| Project Title: | Carlsbad Energy Center - Compliance |
| Document Title: | Project Owner's Responses to Data Requests in Set One (Nos. 1-30) |

Re: Carlsbad Energy Center Project Petition to Amend (07-AFC-06C)
Project Owner's Responses to Data Requests in Set One (Nos. 1 - 30)

Data Response Set 1 (Responses to Data Requests 1 to 30)

| DRAWN BY: DOP | ENCINA POWER STATION FIGURE TSE1c-2 T-LINE POLE CROSS SECTIONS | | | |

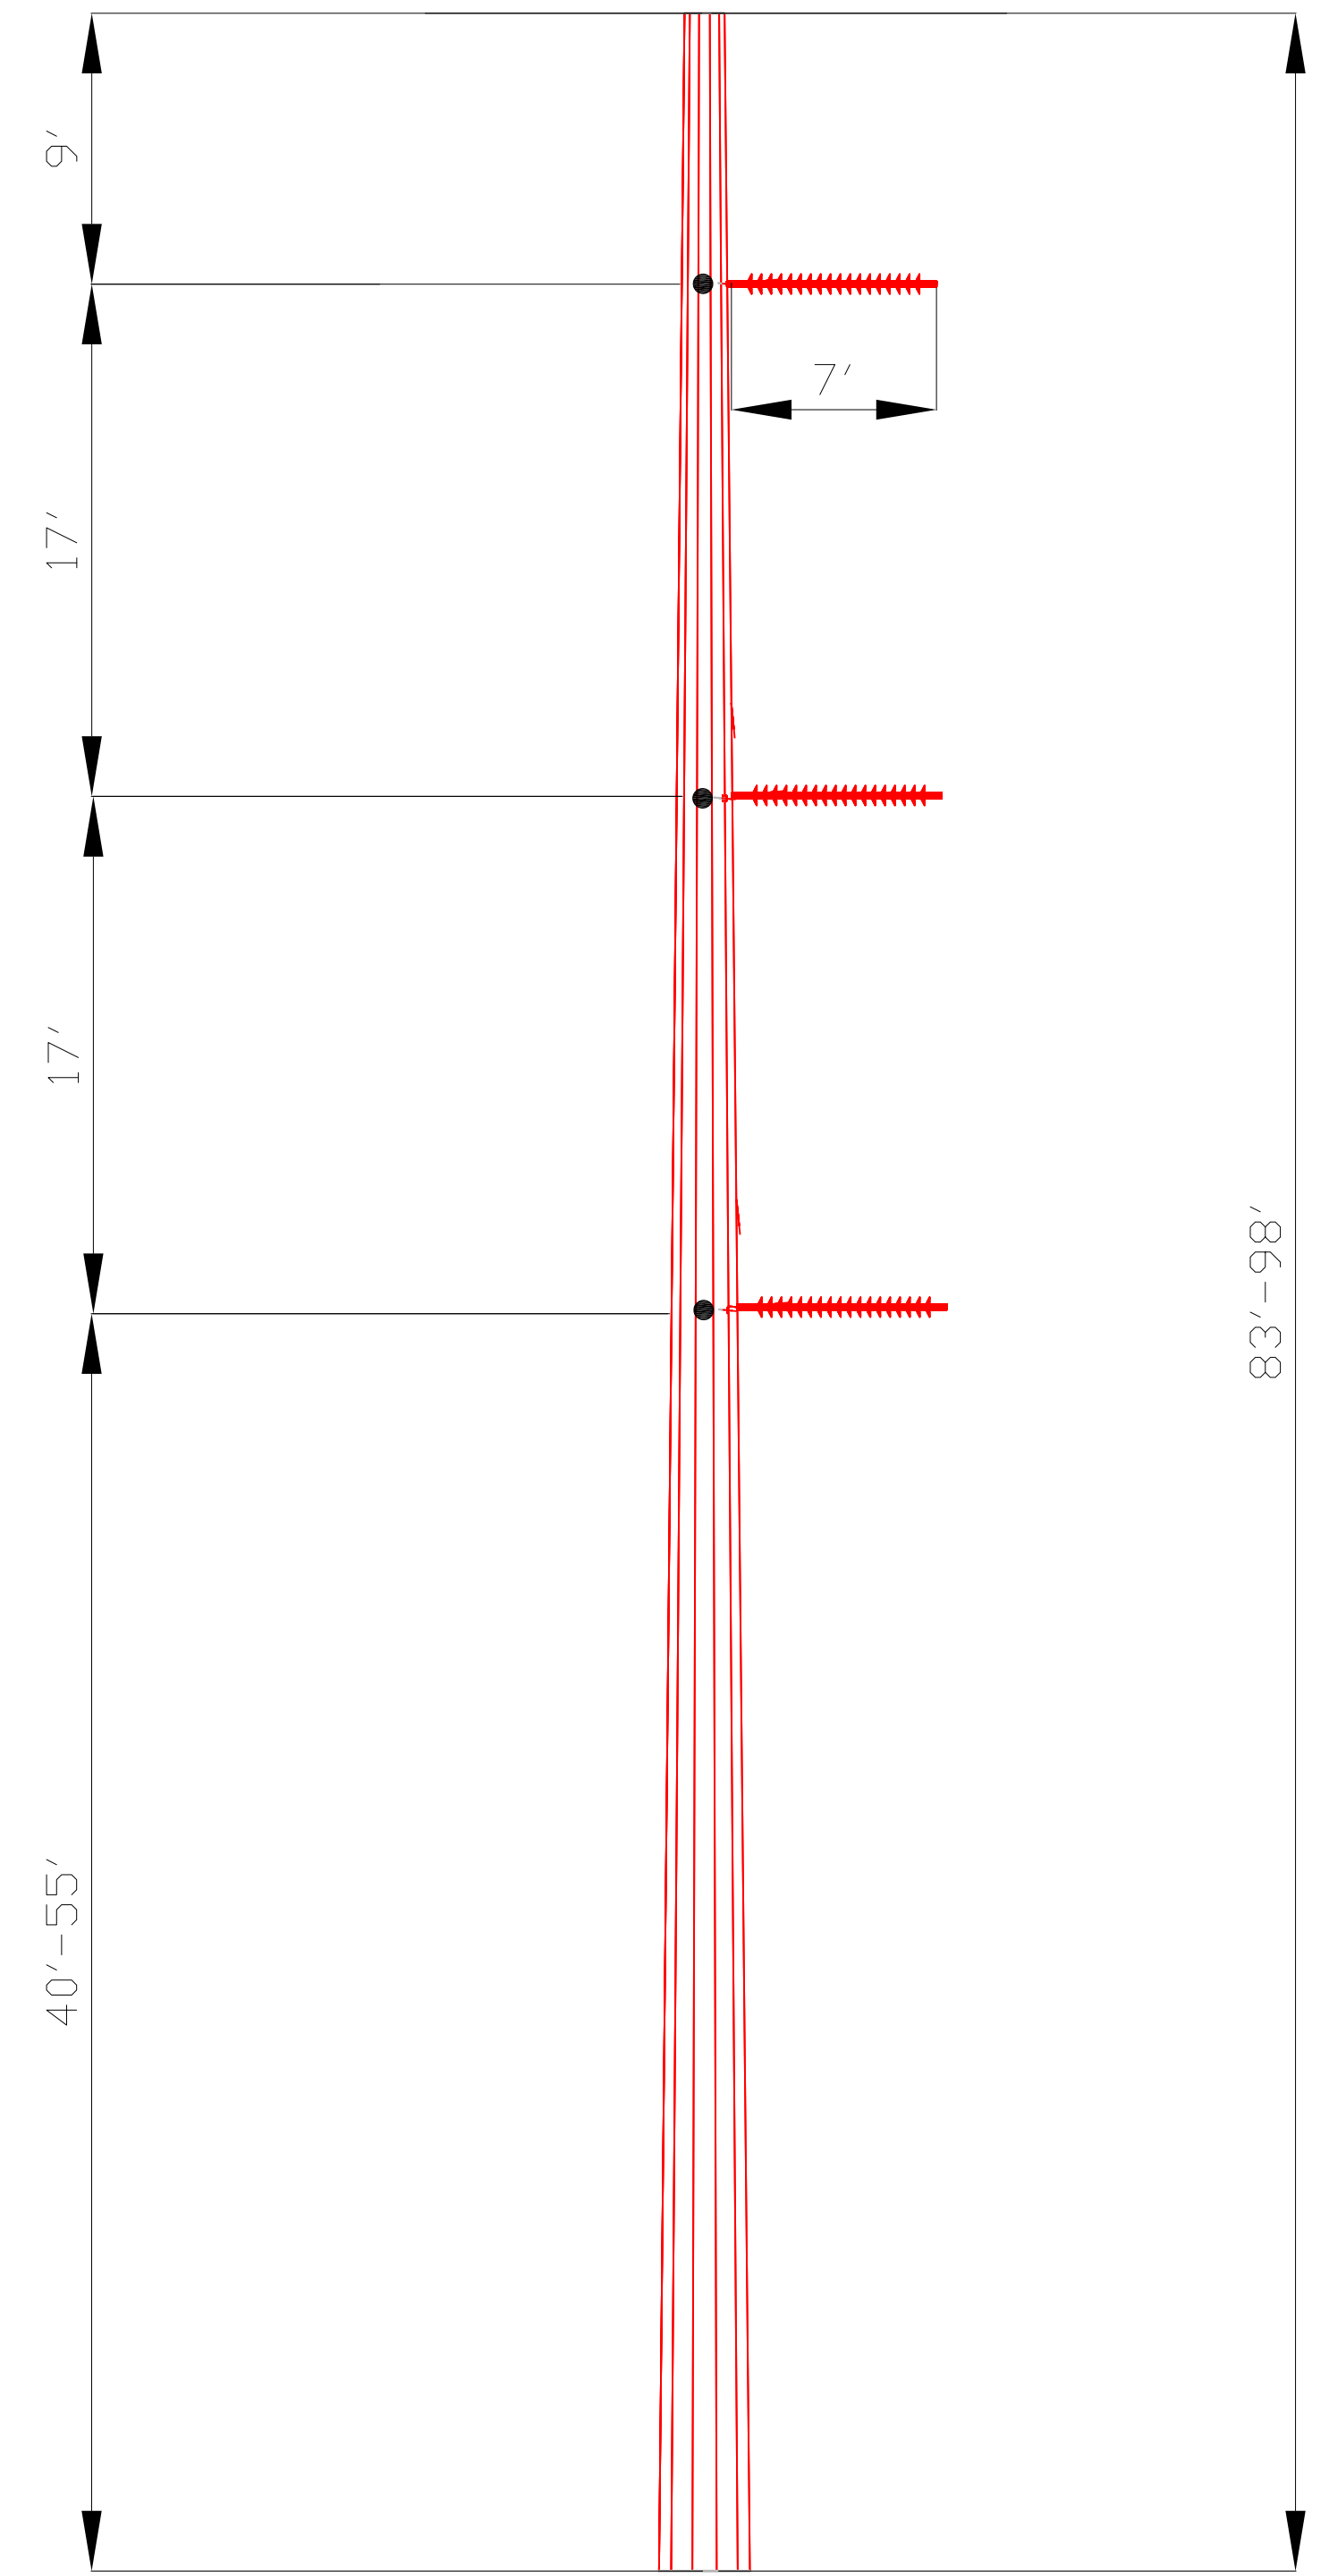
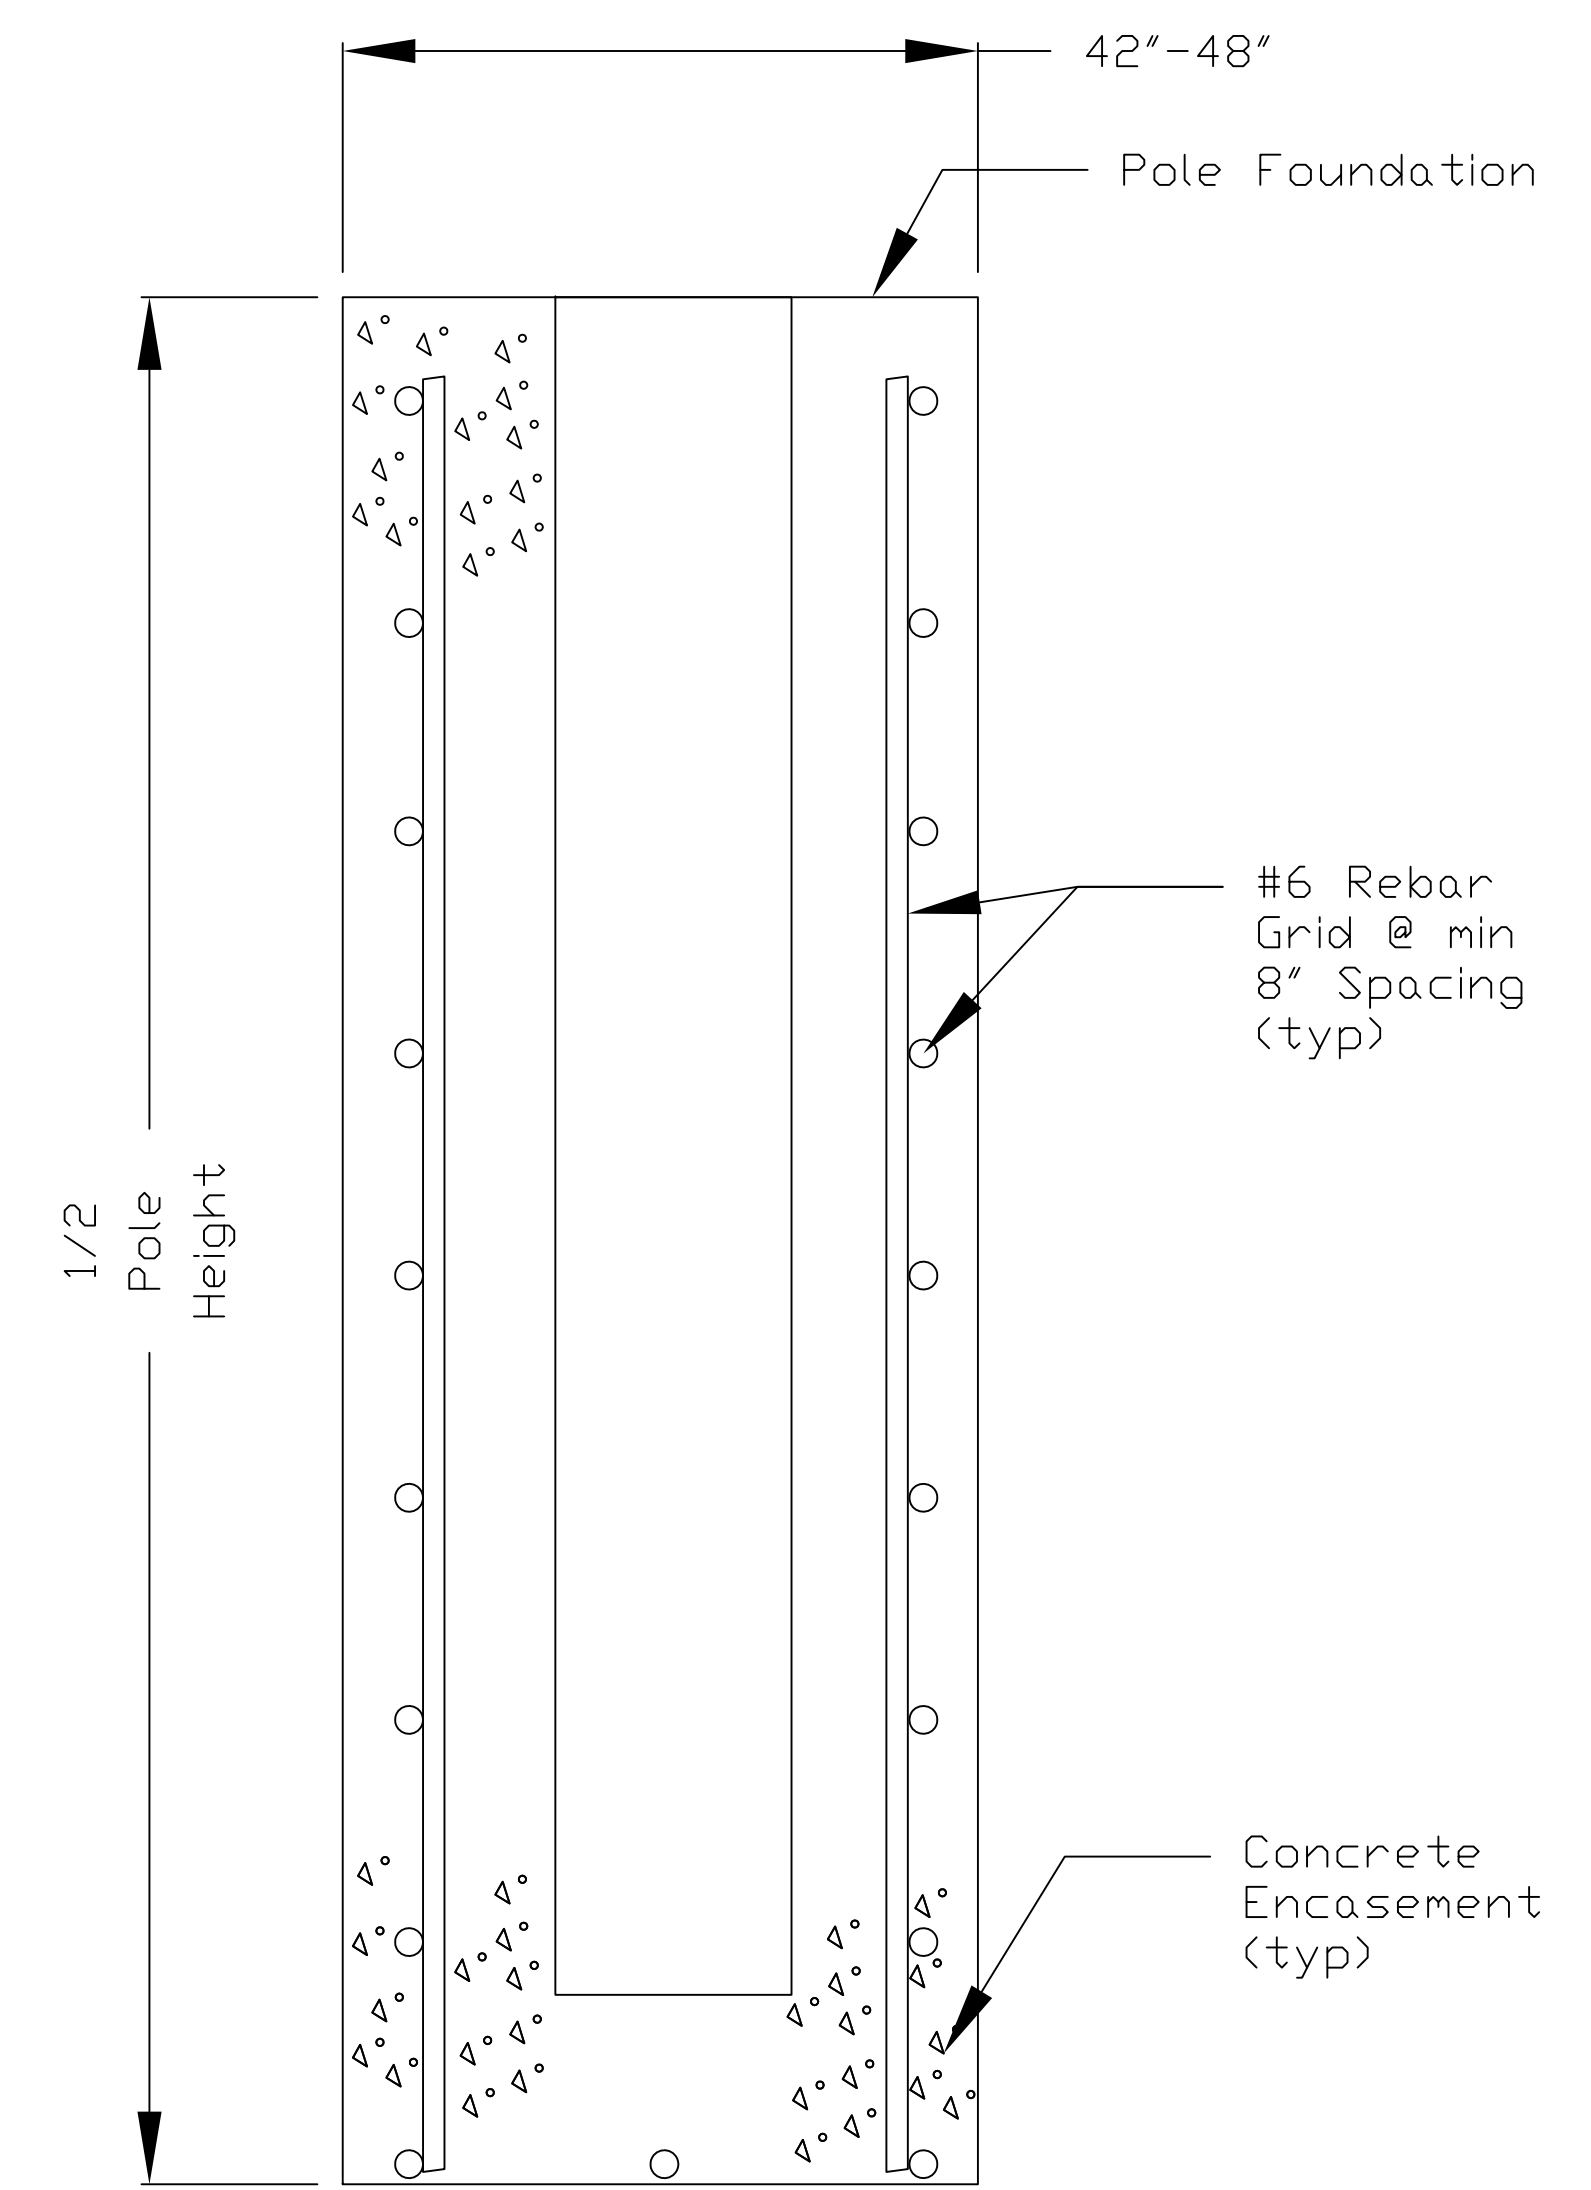
24. Resubmit 138 kV single line dead-end pole diagram (Figure 3.1-5) and 230/138 kV double circuit tangent and dead-end pole diagrams (Figures 3.1-6 & 3.1-7) design diagrams stating type of the pole(s) (steel or wood or any other), length of the insulators, and size & type of overhead conductors. Please show the height of the poles below and above the ground level, conductor-position measurements for the 230 kV and/or 138 kV side of the pole, and between conductors of both sides. Also show and describe any ground conductors, including their size, and provide the ground clearance distance from the lowest conductor on the pole.

Response: As noted in Project Owner's objection to this Data Request, 138kV single line deadend poles are not used in the current design of transmission line. Instead, Project Owner will employ 138kV/230kV double dead-end poles.

Project Owner hereby submits revised versions of the pole drawings that were submitted in the PTA , containing additional information. These are Figures DR24-1 (corresponding to PTA Figure 3.1-5), DR24-2 (PTA Figure 3.1-6), and DR24-3 (PTA Figure 3.1-7). Overhead conductor sizes are shown on Figure DR22-2.
